CF3000530
TABLE CUSHION

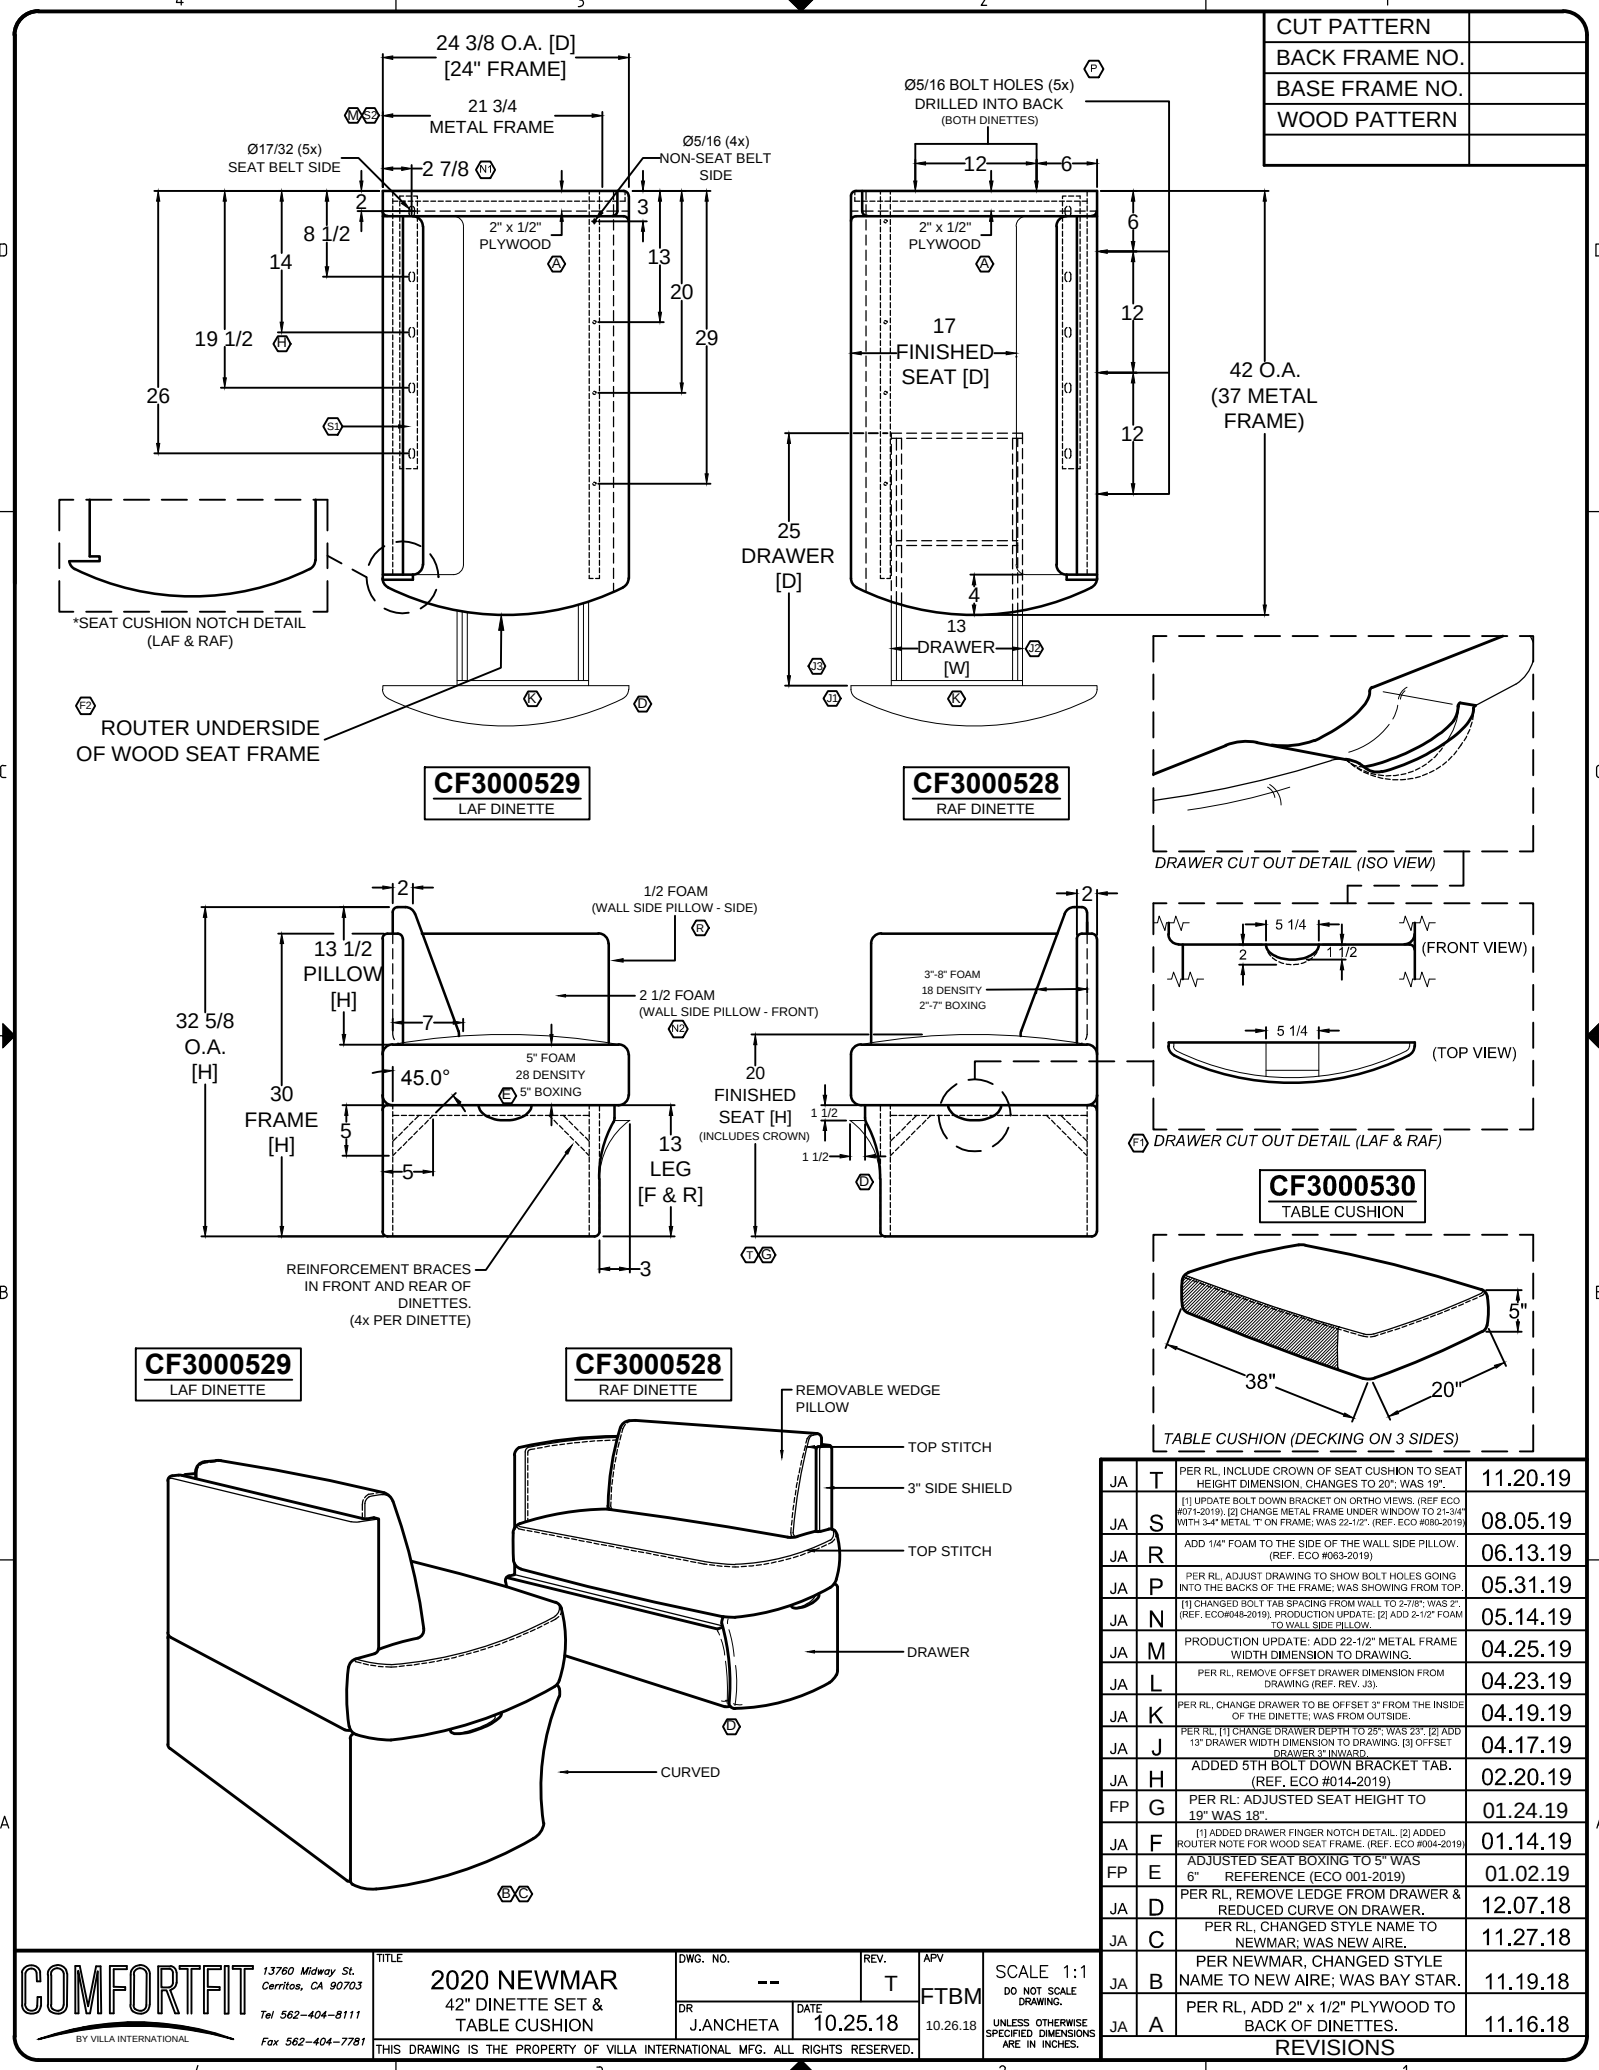
REV.	DATE	DESCRIPTION	BY	CHKD.	DATE
1	11.20.19	PER RL, INCLUDE CROWN OF SEAT CUSHION TO SEAT HEIGHT DIMENSION. CHANGES TO 20" WAS 18".	JA	T	11.20.19
2	08.05.19	[1] UPDATE BOLT DOWN BRACKET ON ORTHO VIEWS. (REF. ECO #07-2019). [2] CHANGE METAL FRAME UNDER WINDOW TO 21-3/4" WITH 3-4" METAL "T" ON FRAME. WAS 22-1/2". (REF. ECO #080-2019)	JA	S	08.05.19
3	06.13.19	ADD 1/4" FOAM TO THE SIDE OF THE WALL SIDE PILLOW. (REF. ECO #063-2019)	JA	R	06.13.19
4	05.31.19	PER RL, ADJUST DRAWING TO SHOW BOLT HOLES GOING INTO THE BACKS OF THE FRAME. WAS SHOWING FROM TOP.	JA	P	05.31.19
5	05.14.19	[1] CHANGED BOLT TAB SPACING FROM WALL TO 2-7/8". WAS 2". (REF. ECO#048-2019). PRODUCTION UPDATE: [2] ADD 2-1/2" FOAM TO WALL SIDE PILLOW.	JA	N	05.14.19
6	04.25.19	PRODUCTION UPDATE: ADD 22-1/2" METAL FRAME WIDTH DIMENSION TO DRAWING.	JA	M	04.25.19
7	04.23.19	PER RL, REMOVE OFFSET DRAWER DIMENSION FROM DRAWING (REF. REV. J3).	JA	L	04.23.19

8	04.19.19	PER RL, CHANGE DRAWER TO BE OFFSET 3" FROM THE INSIDE OF THE DINETTE. WAS FROM OUTSIDE.	JA	K	04.19.19
9	04.17.19	PER RL, [1] CHANGE DRAWER DEPTH TO 28". WAS 28". [2] ADD 13" DRAWER WIDTH DIMENSION TO DRAWING. [3] OFFSET DRAWER 3" INWARD.	JA	J	04.17.19
10	02.20.19	ADDED 5TH BOLT DOWN BRACKET TAB. (REF. ECO #014-2019)	JA	H	02.20.19
11	01.24.19	PER RL, ADJUSTED SEAT HEIGHT TO 19" WAS 18".	FP	G	01.24.19
12	01.14.19	[1] ADDED DRAWER FINGER NOTCH DETAIL. [2] ADDED ROUTER NOTE FOR WOOD SEAT FRAME. (REF. ECO #004-2019)	JA	F	01.14.19
13	01.02.19	ADJUSTED SEAT BOXING TO 5" WAS 6" REFERENCE (ECO 001-2019)	FP	E	01.02.19
14	12.07.18	PER RL, REMOVE LEDGE FROM DRAWER & REDUCED CURVE ON DRAWER.	JA	D	12.07.18
15	11.27.18	PER RL, CHANGED STYLE NAME TO NEWMAR. WAS NEW AIRE.	JA	C	11.27.18
16	11.19.18	PER NEWMAR, CHANGED STYLE NAME TO NEW AIRE. WAS BAY STAR.	JA	B	11.19.18
17	11.16.18	PER RL, ADD 2" x 1/2" PLYWOOD TO BACK OF DINETTES.	JA	A	11.16.18
